NV9USB (Green Label) Obsolescence

Firmware Changes

Hardware Changes - Smart Hopper BR33

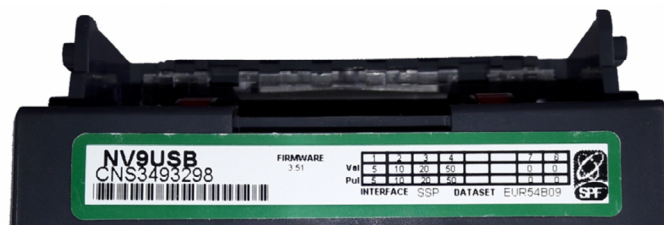
ITL has now ceased support of the NV9USB green label, this includes, currency datasets/firmware and spares. All units in the field will now be over 5 years old.

As such ITL has now ceased support of the NV9USB green label from 1st September 2019.

Please refer to the image on the right, this obsolescence notice **only** affect green label units and **not NV9 USB+**.

BV50 Firmware Version 4.19 Released

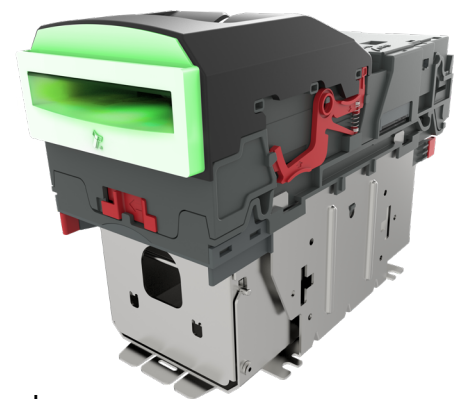
A new version of BV50 firmware has now been released, 4.19. Firmware is contained within the currency dataset files and is available to download free from our website within [Technical Support/Currency Download](#).

- Added support for hold note after a reject
- Added SPF2.1 support

NV10 USB+ Firmware Version 3.46 Released

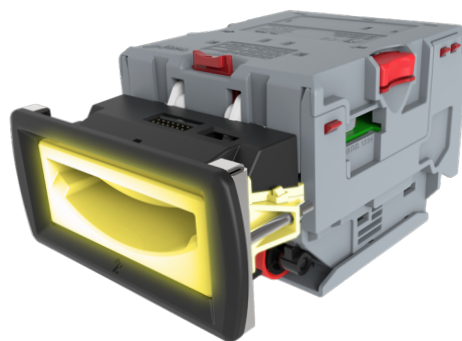
A new version of NV10 USB+ firmware has now been released, 3.46. Firmware is contained within the currency dataset files and is available to download free from our website within [Technical Support/Currency Download](#).

- Added SPF2.1 support
- Improved polymer note handling

SMART Coin System Firmware Version 1.24 Released

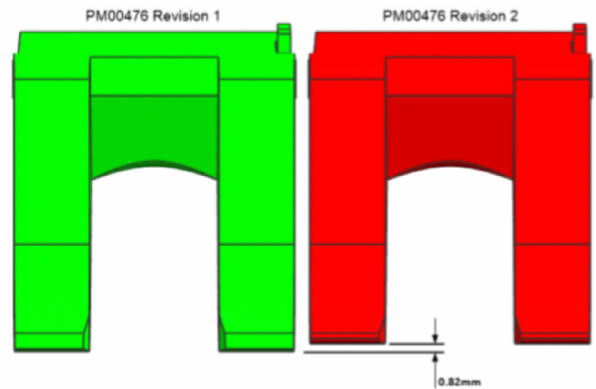
A new version of SCS firmware has now been released, 1.24. Firmware is contained within the currency dataset files and is available to download free from our website within [Technical Support/Currency Download](#).

- Added ccTalk packet download
- Improved GBP processing
- Improved metal detect trigger
- Improved empty routine
- Improved SD card handling
